Access Compliance Report Public Rights-of-Way (Curb Ramps)

Intersection ID: 14971 Main Street: PIERCE_ST Cross Street: SCOTT_AV Location: W

ADA ID: C8C649F9903B Ramp Type: Directional1 Initial Pass/Fail: Fail Overall Compliance: No Severity Score: 12.5

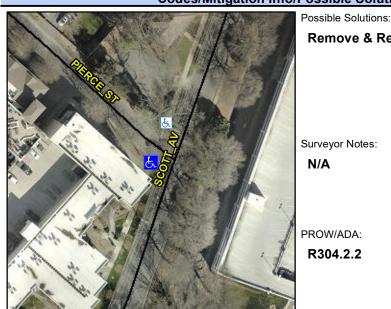
Remove & Replace Entire Ramp.

PROW/ADA:
R304.2.2

Compliance Description Data Compliance Description Data N/A Grade Break? N/A Ramp Length (in) 91.0 N/A 59.0 N/A Yes Ramp Width (in) Grade Break Slope (%) 0.0 N/A No Ramp Slope (%) 9.9 Grade Break XSlope (%) 0.0 Ramp XSlope (%) 0.6 Yes N/A Flare Type LT N/A N/A Flare Type RT N/A N/A Flare Slope LT (%) N/A N/A Flare Slope RT (%) 0.0 N/A Flare Traversable LT? N/A N/A Flare Traversable RT? N/A 0.0 N/A **DWS Provided?** Landing Length (in) N/A Landing Width (in) 0.0 N/A **DWS Contrast?** N/A Landing Slope (%) 0.0 N/A DWS Length (in) N/A N/A Landing X Slope (%) 0.0 DWS Full Width? N/A Landing Curb? (Y/N) N/A N/A DWS Offset LT (in) N/A Shared Landing? N/A N/A DWS Offset RT (in) N/A **Gutter Ponding?** 0.0 N/A Gutter Slope (%) N/A Gutter Lip Ht (in) 0.0 N/A Gutter X Slope (%) N/A Painted X Walk1? No Road Slope (%) 5.9 X Walk 1 Direction To N Road X Slope (%) 4.6 X Walk 1 Width (in) N/A Clear Space? N/A 5.9 N/A N/A X Walk 1 Slope (%) Clear Space to XWalk (in) X Walk 1 X Slope (%) 4.6 N/A Storm Grate/Utility Hazard? N/A Ramp inside XWalk1? N/A Storm Grate/Utility Type N/A Any Obstructions? N/A **Obstruction Type** Surface Condition? (G/P) Yes Good N/A N/A Curb Slope (%) 8.6
